Access Compliance Report Public Rights-of-Way (Pedestrian Signals)

Main Street: **NEWPORT_BLVD** Cross Street: **COWAN_HEIGHTS_DR** Location: **SE**

ADA ID: **SGRK211012151917** Signal Type: **One Push Button-APS** Overall Compliance: **No** Severity Scores: **BTN 1: 25** **BTN 2: N/A** **No BTN: N/A**

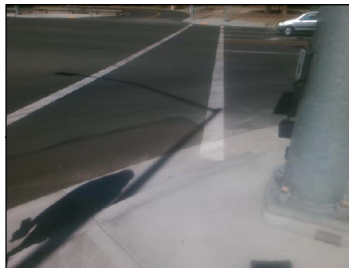
OC Std/PROW: **R404.2, R404.3**

Possible Solutions: Remove and Replace Clear Space.
